ADDENDUM NO. 1
March 4, 2022

DLH Runway 3-21 Lighting and Signage Replacement
City of Duluth No. 21-4401
AIP No. 3-27-0024-072-2022
Duluth International Airport (DLH)
Duluth Airport Authority

SEH No. DULAI 164242

SHEET TITLE
ELECTRICAL
DEMOLITION PLAN 1

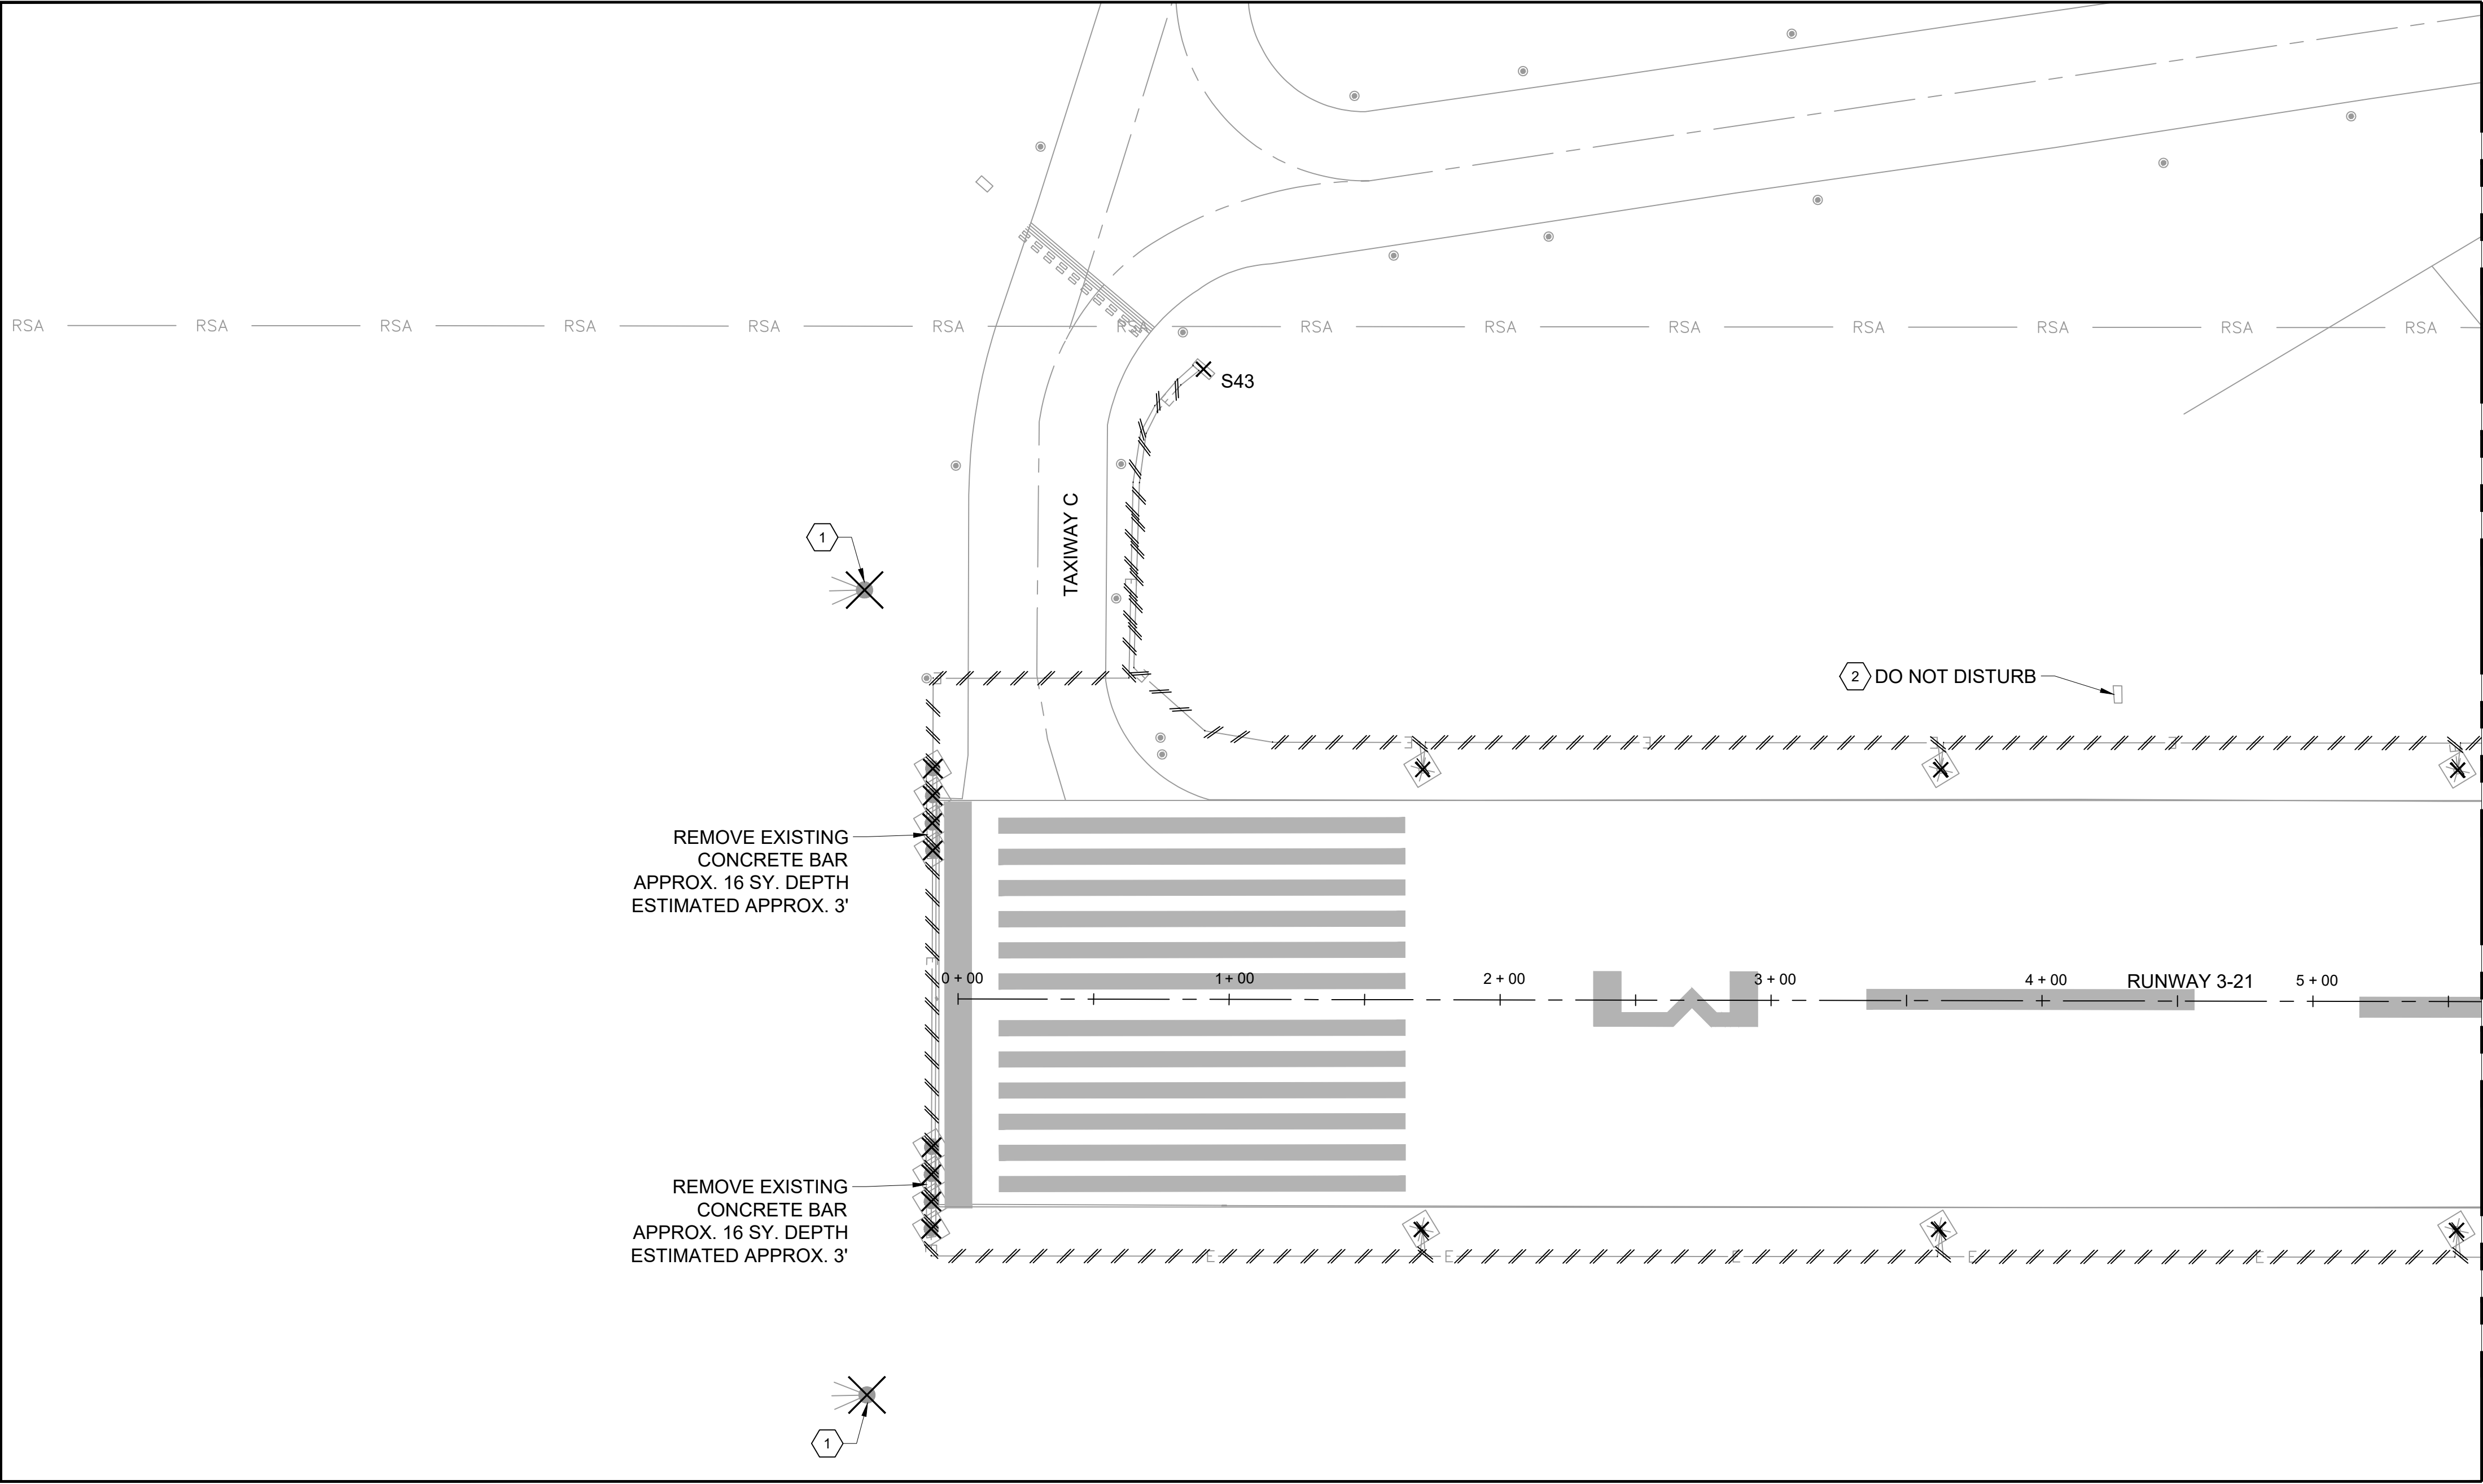
7. Drawing ED-101 Electrical Demolition Plan 1 – Updated keyed note #1. Existing REIL equipment shall be turned over to the FAA.
8. Drawing E-100 Proposed Signage Plan – Bid Alternate Sign Schedule Added. If the Bid Alternate is awarded this signage schedule shall apply. If the Bid Alternate is not awarded, only the Airfield Sign Schedule – Base Bid shall apply.

COORDINATE WITH LOCAL FAA ON WHERE TO DISCONNECT POWER FOR EXISTING REILs, LOCATION OF EXISTING CIRCUITS, AND EXTENT OF REMOVAL. LOCATE AND REMOVE EXISTING FAA CURRENT SENSOR WIRE. EXISTING REIL EQUIPMENT SHALL BE TURNED OVER TO FAA. SHOULD THE FAA REFUSE THE EQUIPMENT, THE CONTRACTOR SHALL DISPOSE OF AT CONTRACTOR'S EXPENSE.
- 2

SHEET
E-101

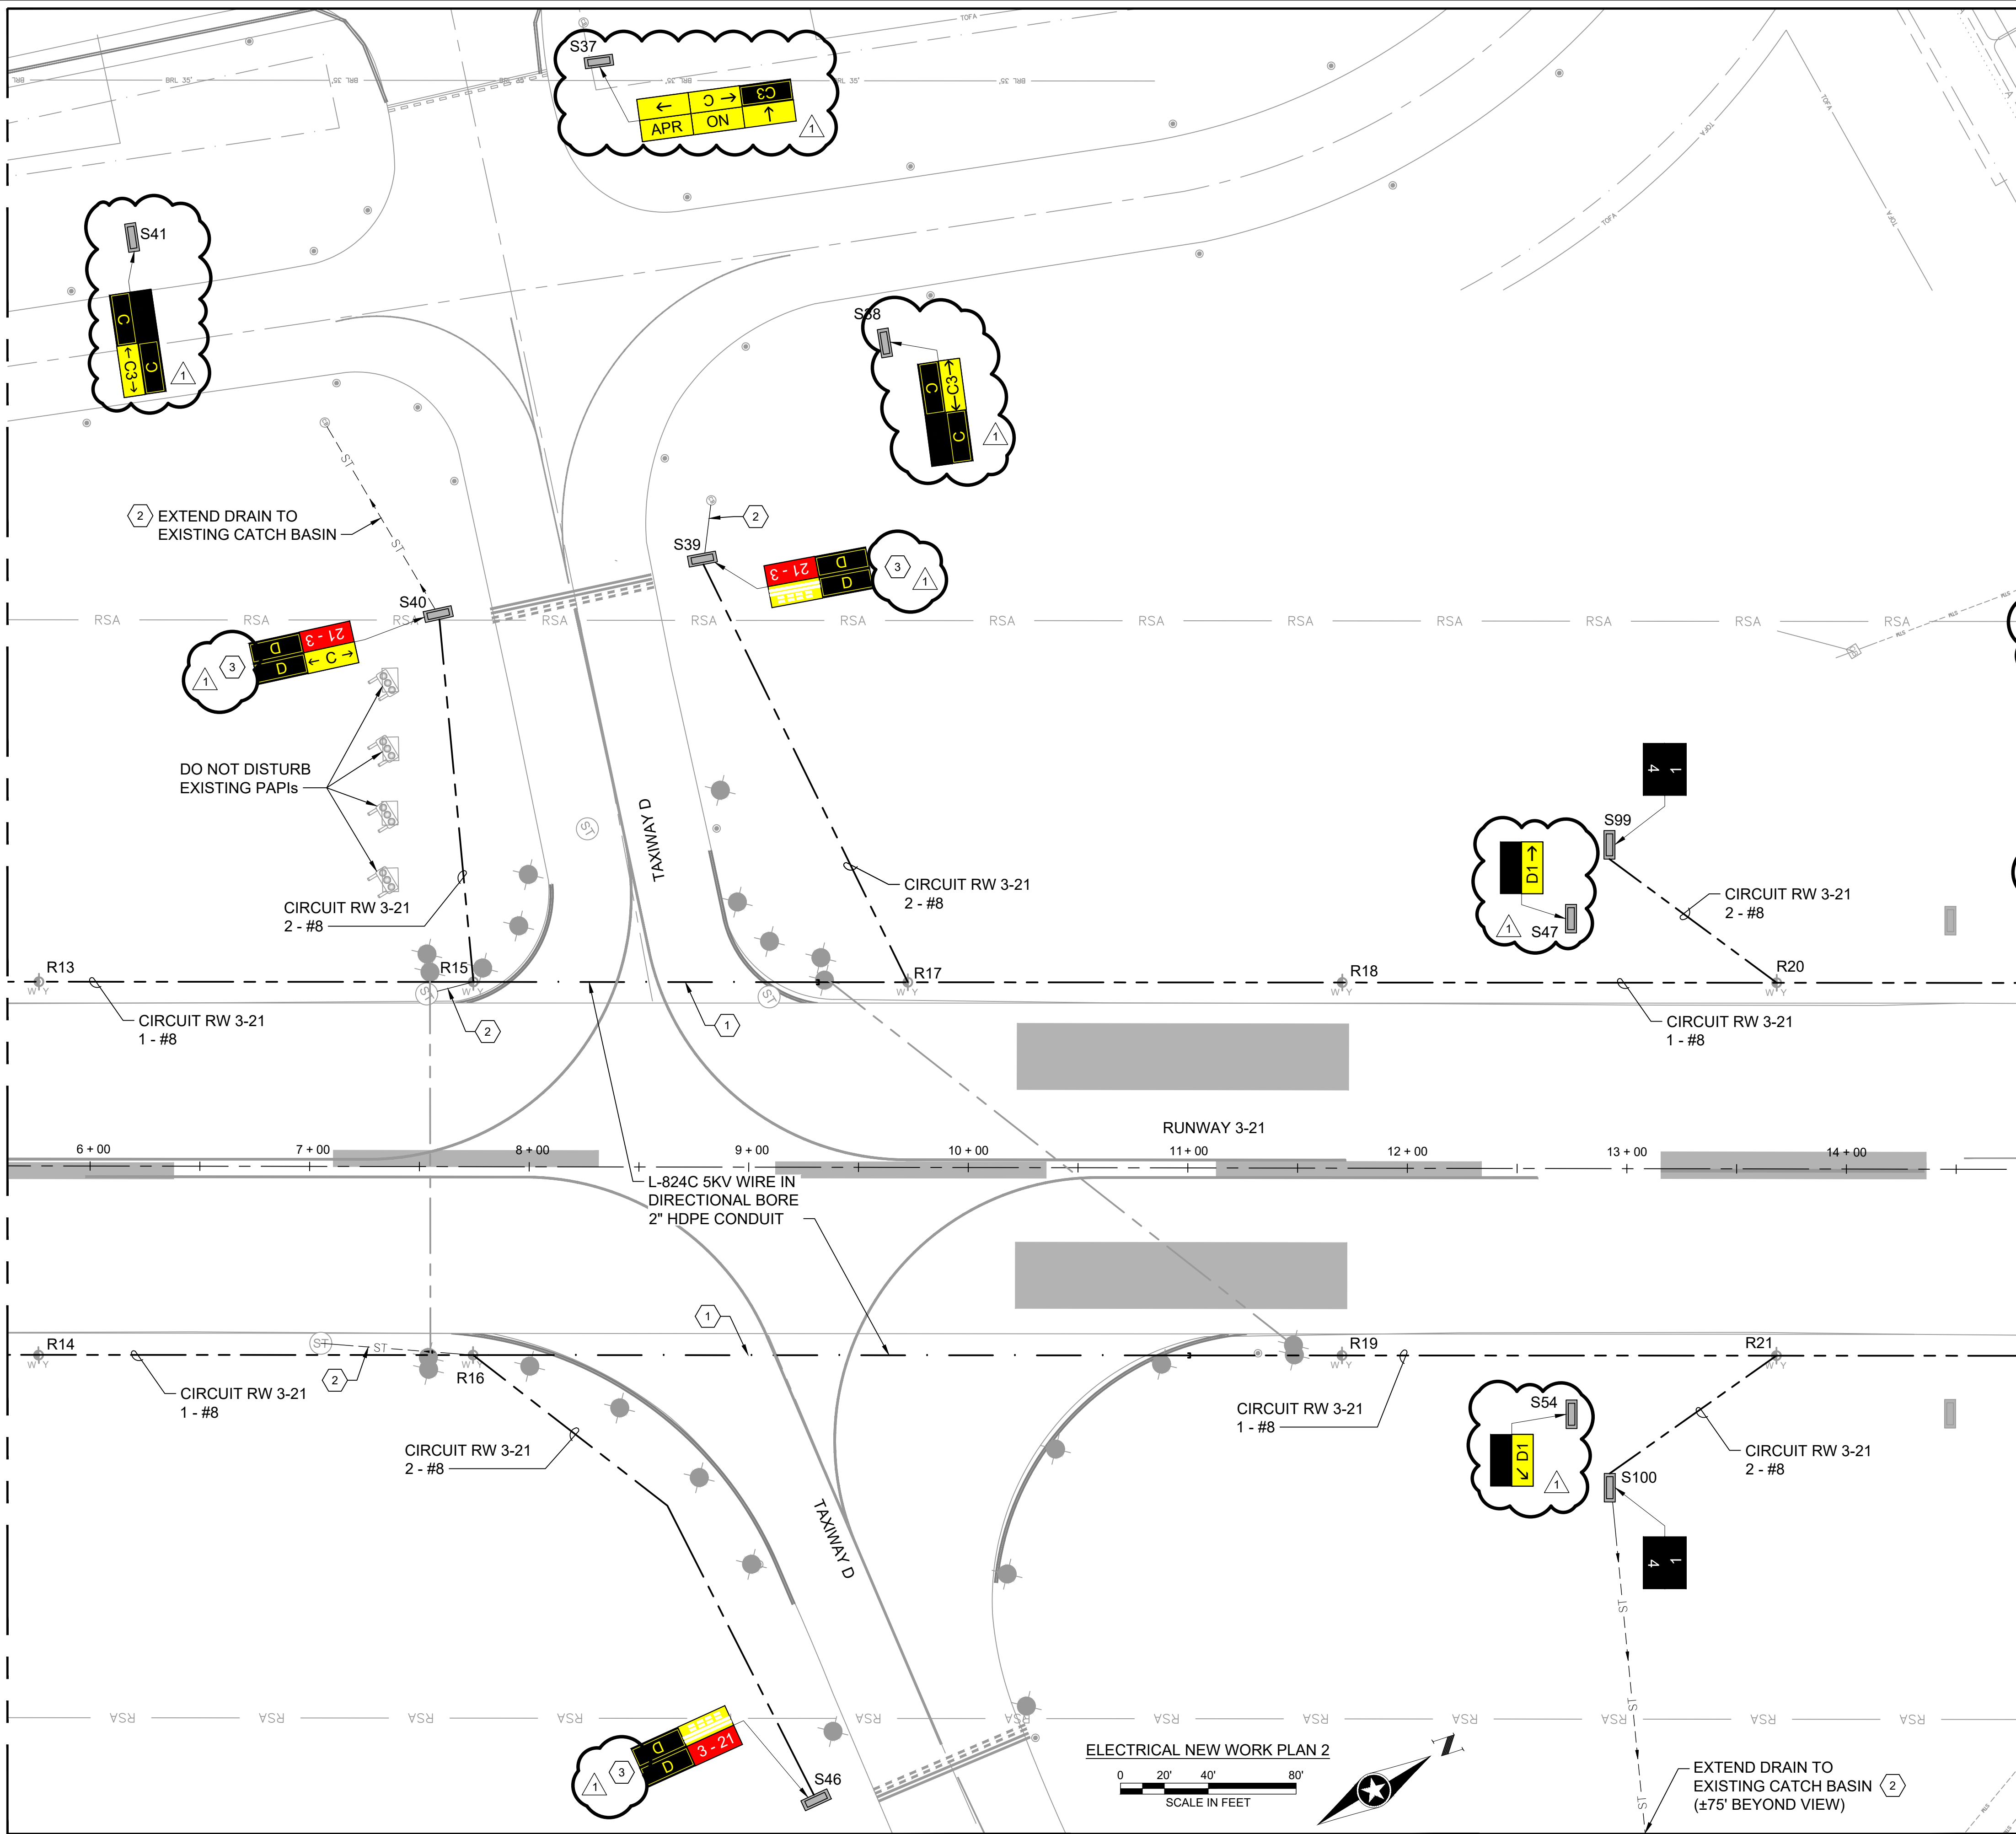
9. Drawing E-101 Electrical New Work Plan 1 – Bid Alternate Sign Schedule Added. Signs affected by alternate bid sign schedule are identified in the Electrical New Work Plan and notes have been updated.
